GENERAL APPLICATION

Location Address: 2022 & 206 Fletcher Street

**RE: 2022-2026 Fletcher Street
Response to Landscape Comments Received**

SUBJECT: Preliminary Site Plan review for a 42- Unit residential development.

DRAWN	C.C.
CHECKED	LLR
DATE	11/08/21
SCALE	AS NOTED
JOB. NO.	021-0210
SHEET	
	SP-1.1
OF	SHEETS

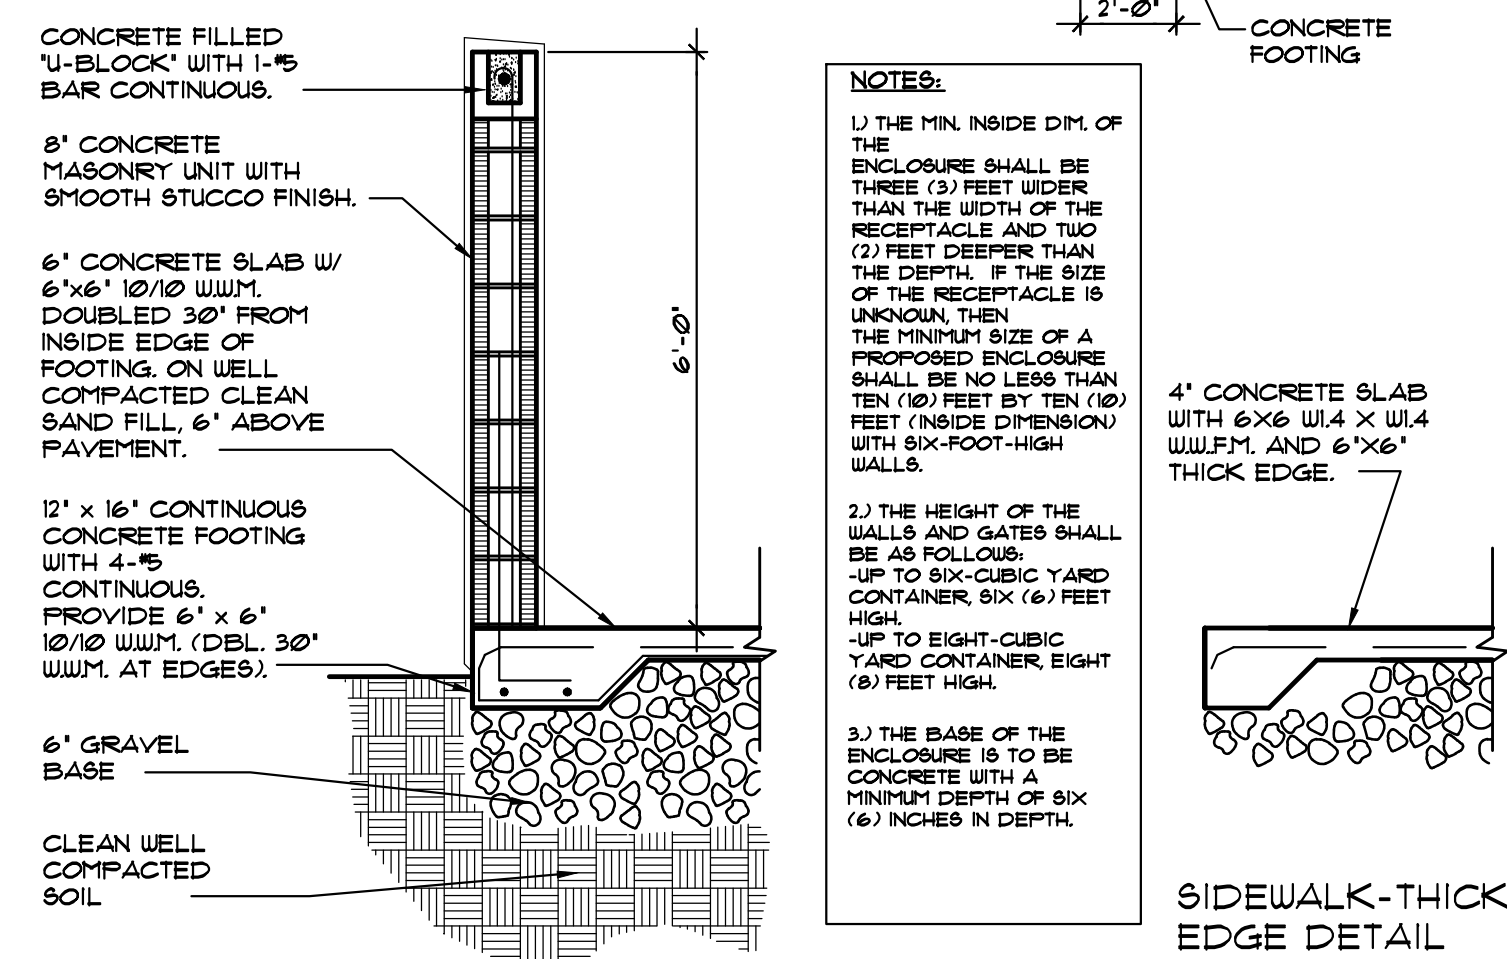
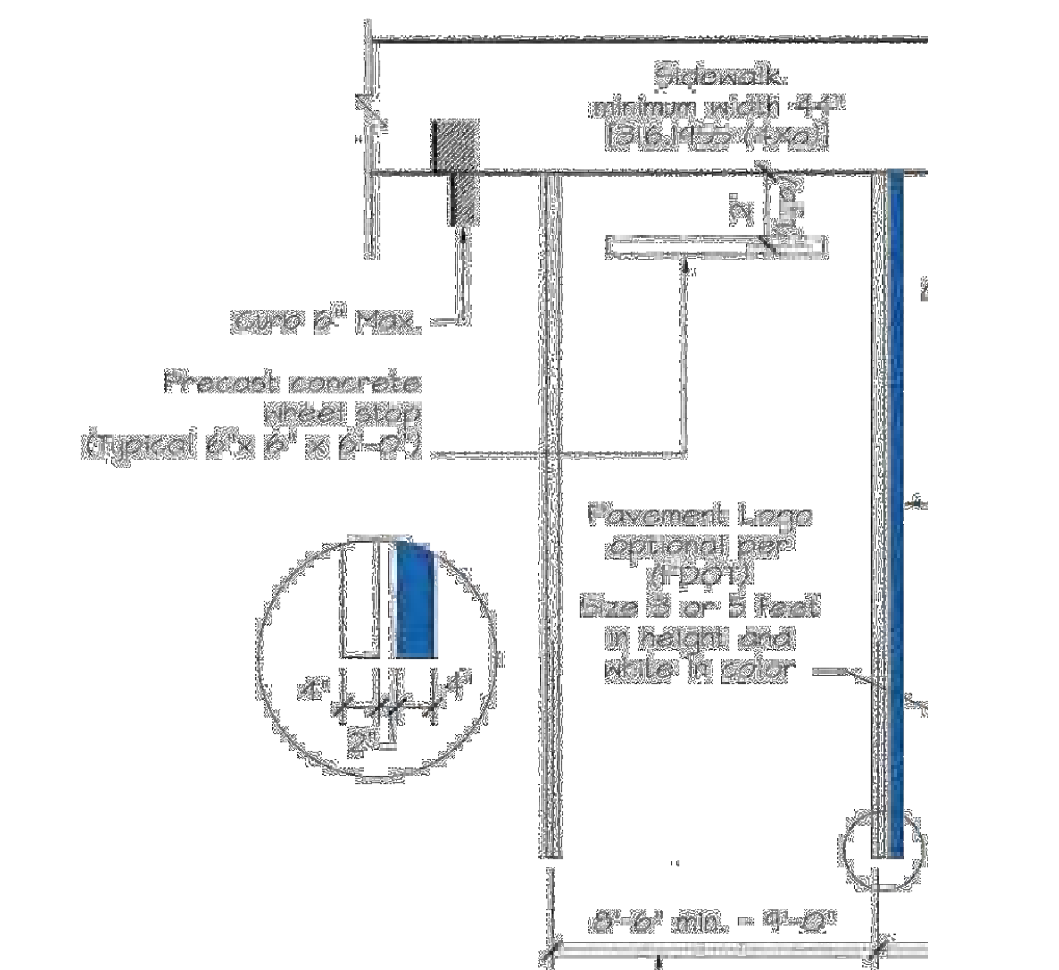
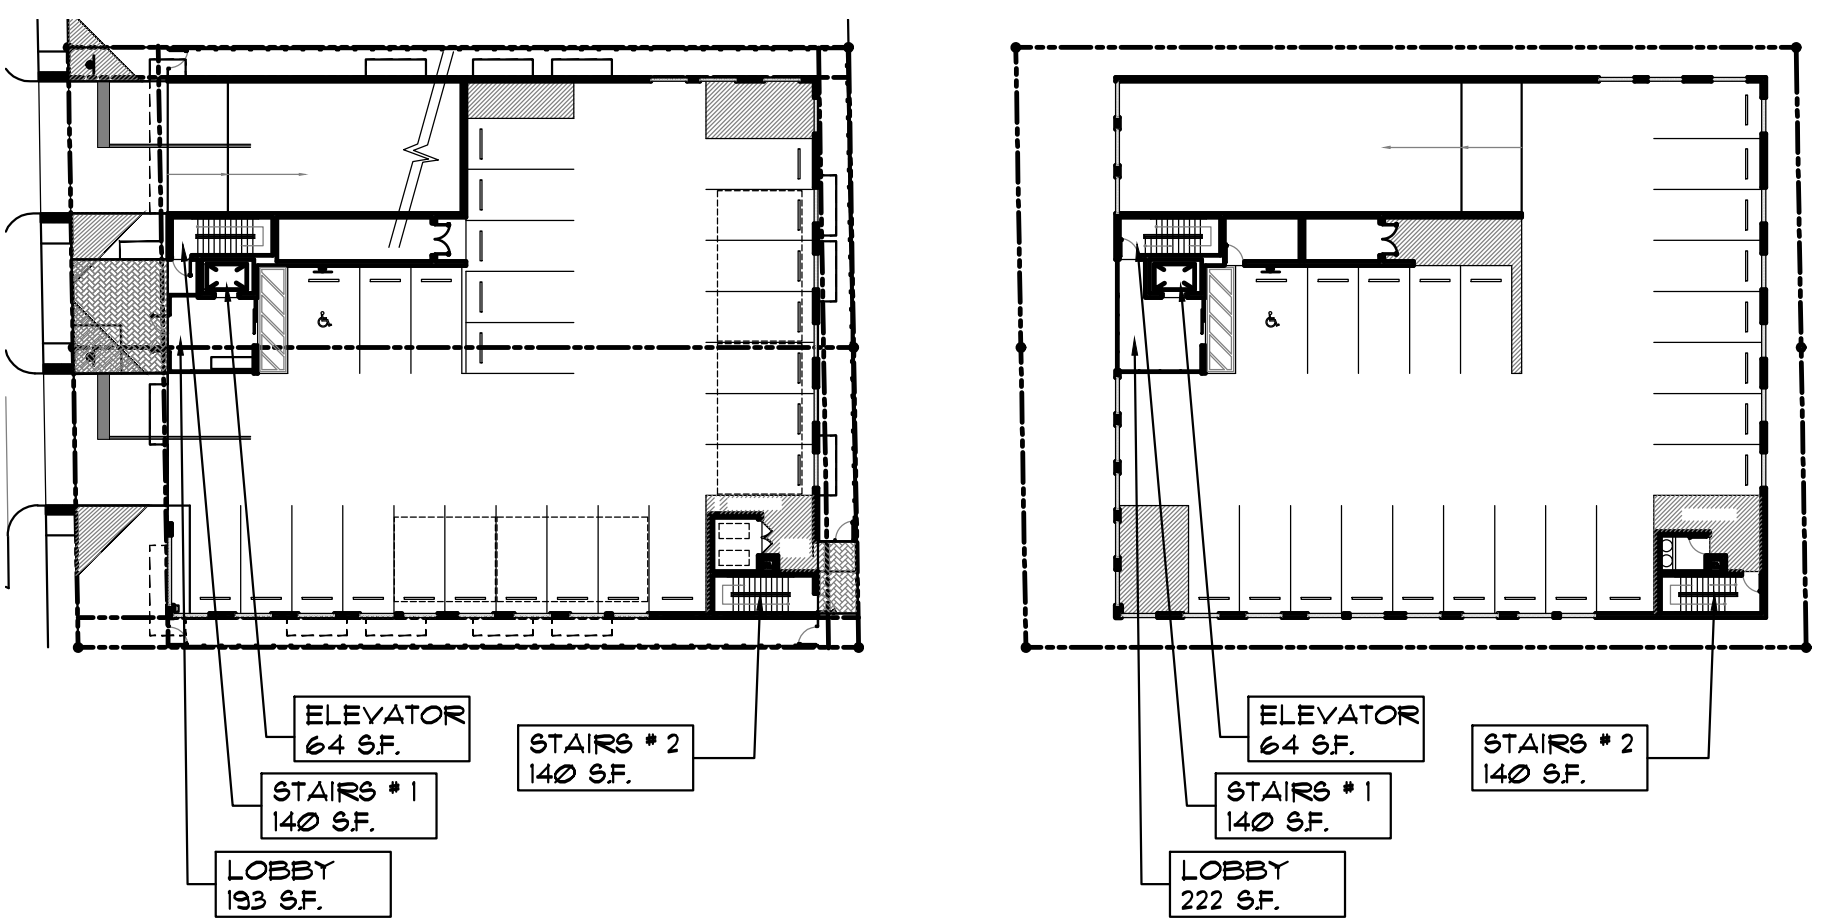
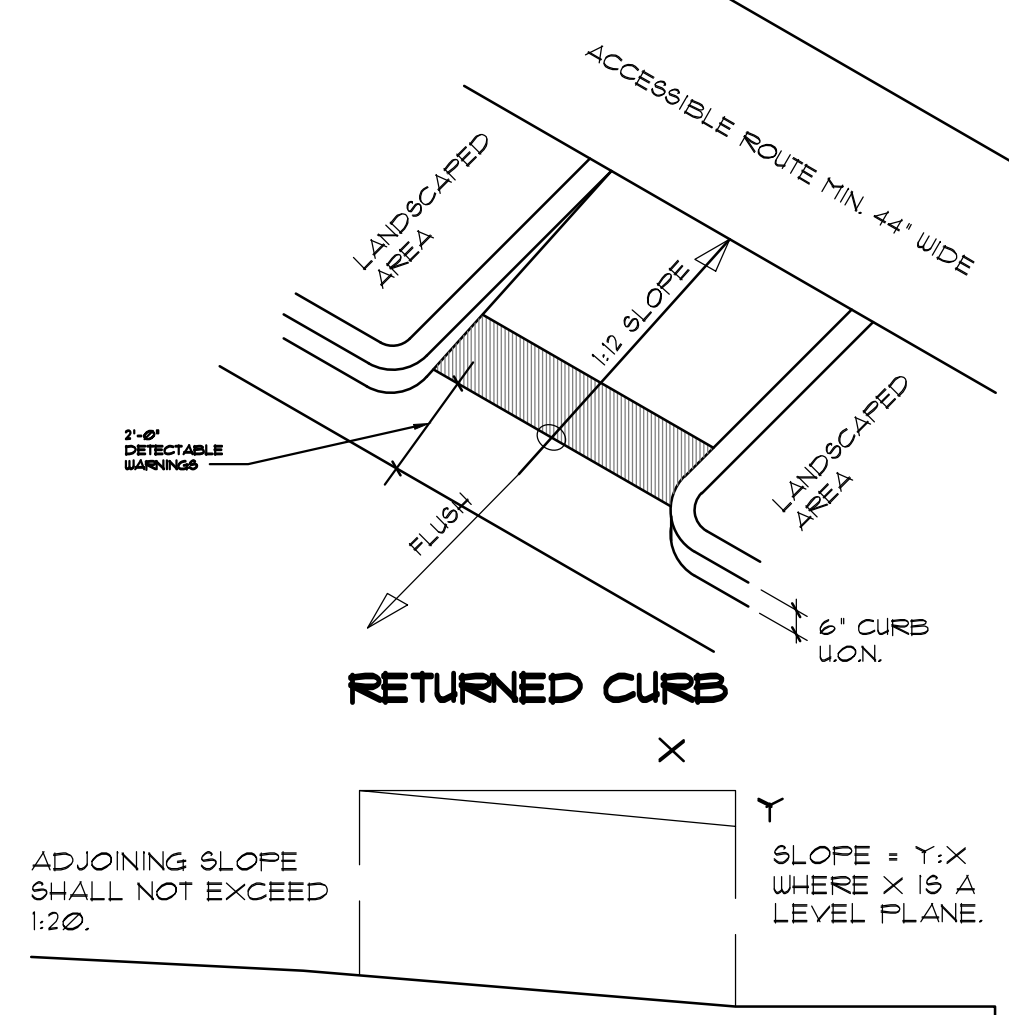
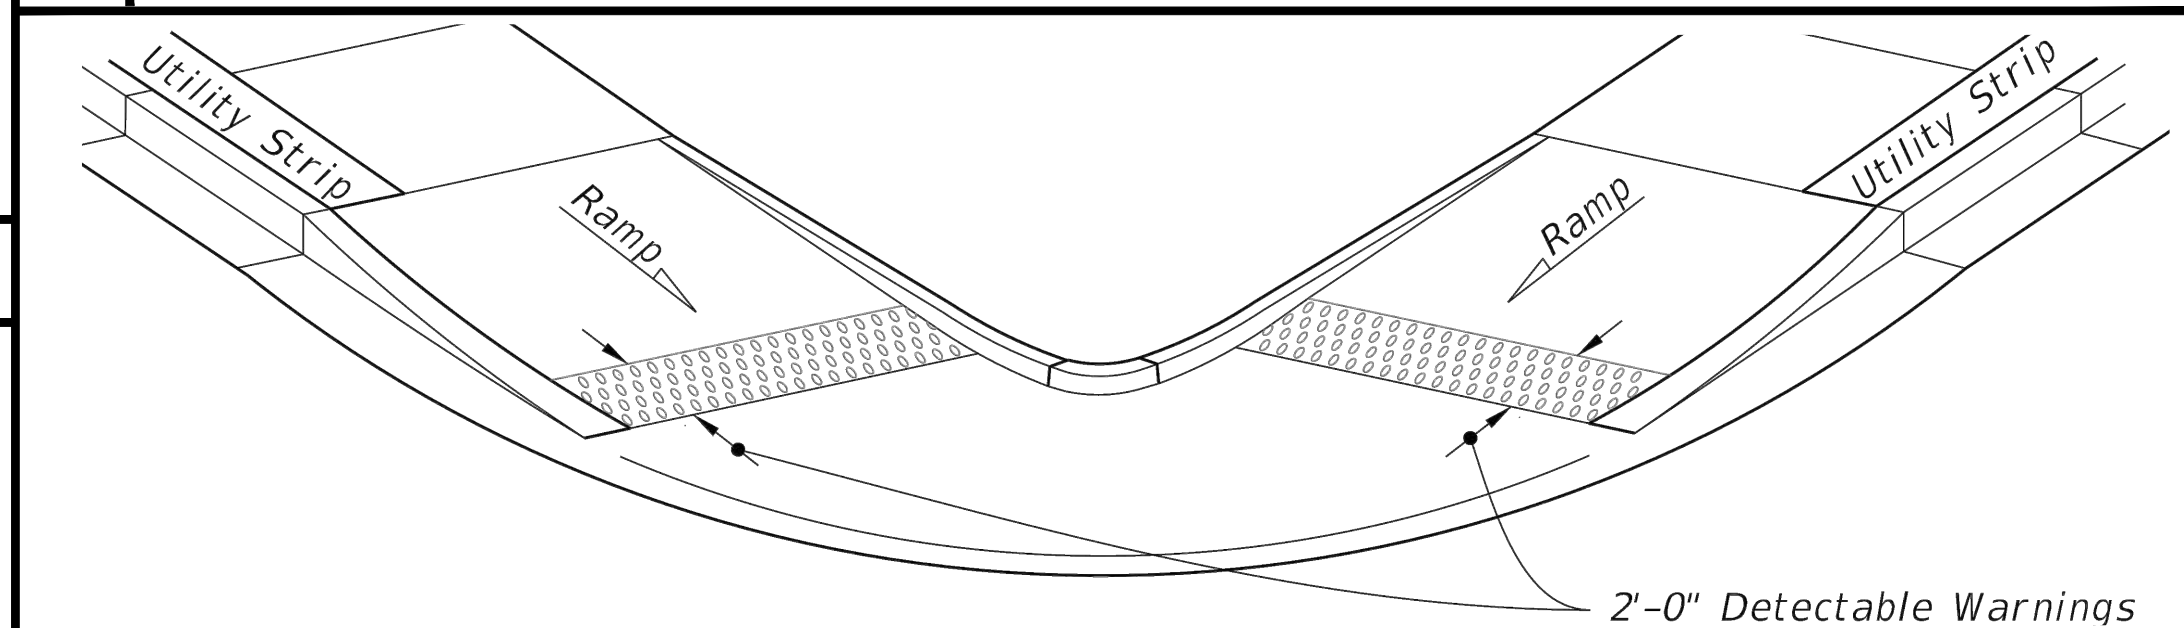
1. A portion of the property is within 100 feet of property zoned PS-1. Graphically depict on the site plan and floor plans the portion of the property within a 100 ft radius to property zoned PS-1. Based on the submitted elevations, it appears that the north-eastern corner of the building exceeds the maximum permitted height of 55 feet for property within 100 feet of a PS-1 zoned property. The height of the building may need to be reduced to comply.

- b. Include the required and proposed height for the portion of the property within 100 feet of property zoned PS-1.
Response: added diagram showing adjacent PS-1 zoning and 100' radius. Also, added note to Height calculations on Sheet SP-1.1.

Response: Revised Accordingly
- f. Include the provided FAR as a ratio, not just the overall provided square footage.
Response: Provided on SP-1.1
- g. Per Sec. 4.6.B.3.a.(7), include the minimum required and provided dwelling unit sizes and cumulative averages.

Response: Refer to note 5 on SP-1.1.
- 6. Lifts or tandem parking spaces shall be assigned to one unit only and not be used for guest parking. Provide a note on the Site Plan.

Response: Revised Accordingly, Added Note 6 on SP-1.1
- 7. There are 10 lifts and 35 single spaces; however, there are 10 (2-bedroom) units, 32 (1-bedroom) units and the project requires 5 guest parking spaces. The project is missing 3 single parking spaces.

1. Indicate on the site plan where the infrastructure necessary for future installation of electric vehicle charging equipment will be located. (See 151.154, Ordinance O-2016-02) Consider placing it adjacent to a handicapped space so that the future charger will be accessible from both types of spaces.

5. Sheet SP-1.1, in the Parking Calculations table, indicate the rate used to calculate the number of Guest parking stalls being provided.

Response: Refer to Note 1 on SP-1.1
2. Site Plan:
 - a. Include a note on the site plan indicating that all changes to the design will require planning review and may be subject to Board approval.

Response: Provided on SP-1.1
- 4. Identify location of guest parking spaces on the site plan.
Response: Revised Accordingly
- 5. Add a note to the site plan that the parking lift system shall not be for the use of guests.

Response: provided on SP-1.1

Response: Revised plan shows full compliance with parking requirements.

SP-1.3

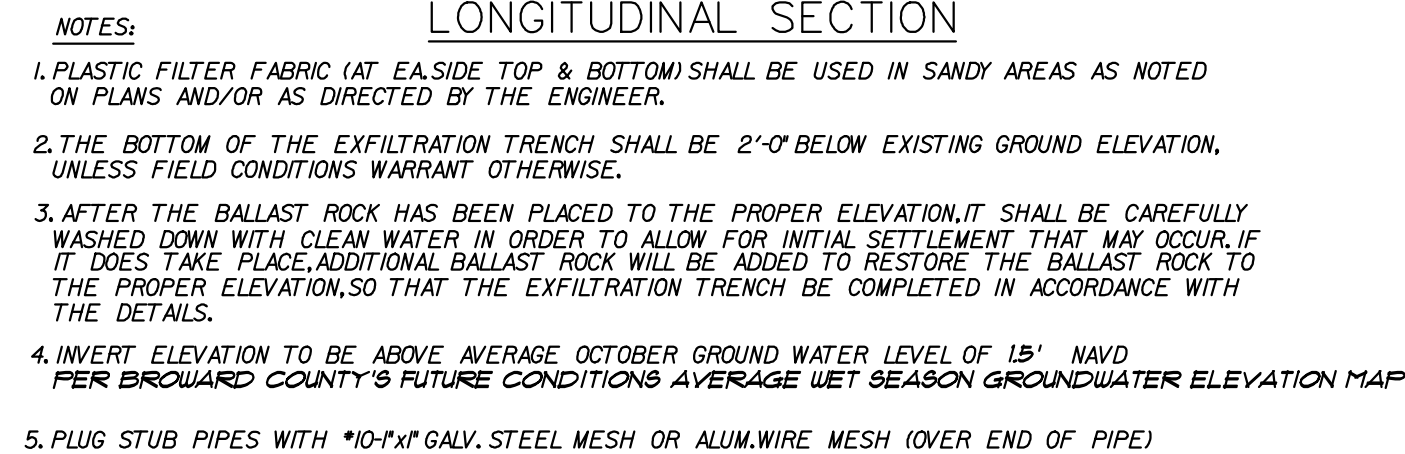
14. Provide a detail for the proposed bike rack.

10. Provide a detail for the fence and all gates. Ensure the design is compatible with the building.

Response: Refer to SP-1.3

Response: refer to SP-1.3
